IEAPM Ref: IEAPM202512-11

Moolarben UG4 EP LWs 409-414

Re: IEAPM's Responses to DPHI Request for Supplementary Advice

Figure 1a: Continuous and manually recorded water level data for PZ234C – Permian strata (from Enclosure 3 of Yancoal (2025f))

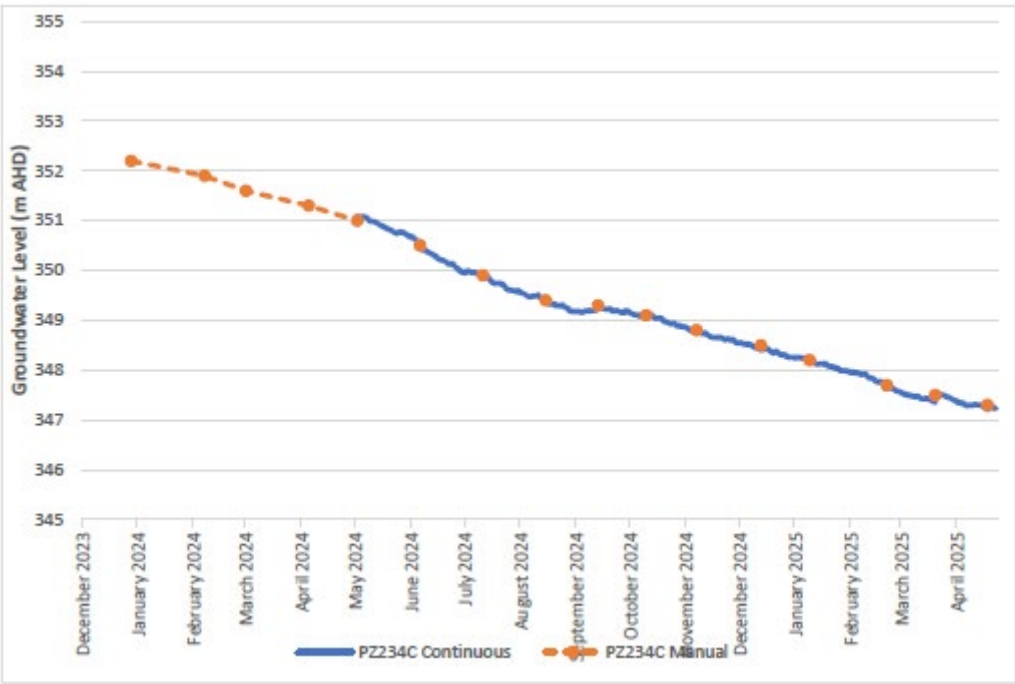
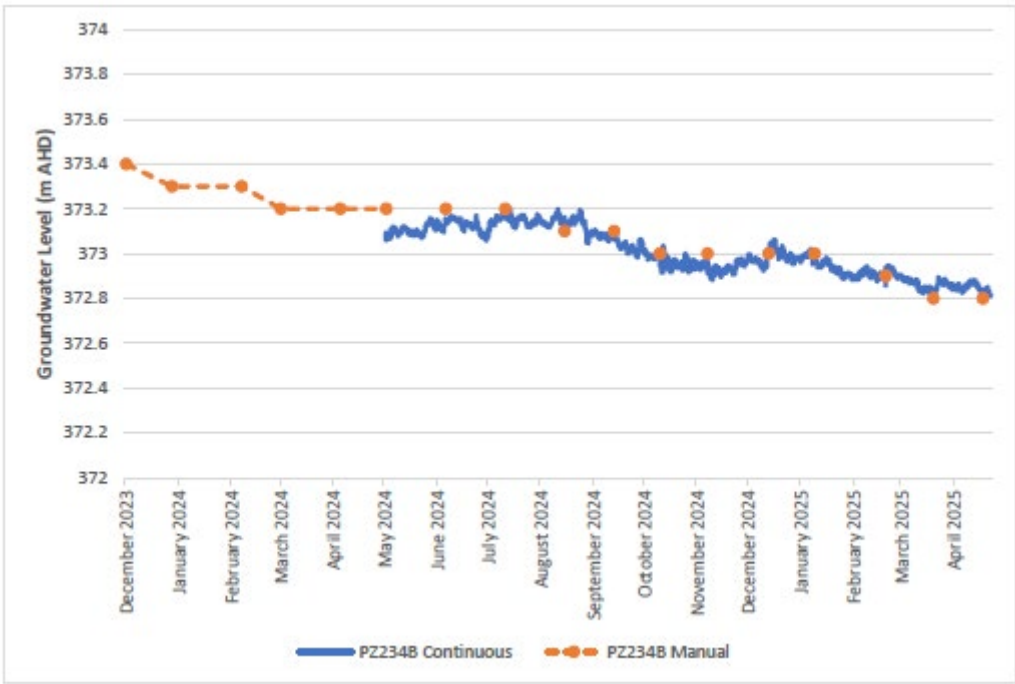
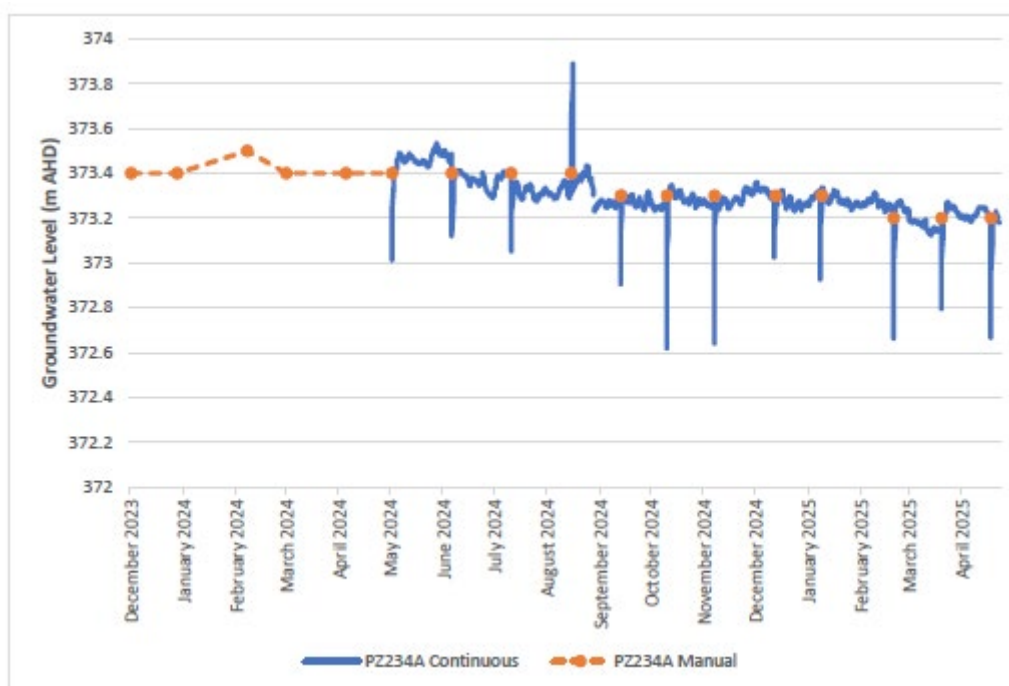
There is already objective data from groundwater standpipes PZ234A, B and C located at the Corner Gorge that mining-induced depressurisation/dewatering of the Permian strata associated with the extraction of LWs401-408, can cause the drainage of groundwater from the Triassic sandstone and impact the regional water table. Relevant PZ234 hydrographs from the Permian strata, base of the Triassic sandstone, and uppermost Triassic sandstone up until April 2025 are shown in Figures 1a, 1b, and 1c respectively. Interestingly, the water level in August 2025 at PZ234A (the regional water table) is even lower at ~373 mAHD (Yancoal, 2025d). The Panel does not consider that the evidence presented in Yancoal (2025e) demonstrates that the drawdown observed at PZ234A is solely or primarily climate-related.
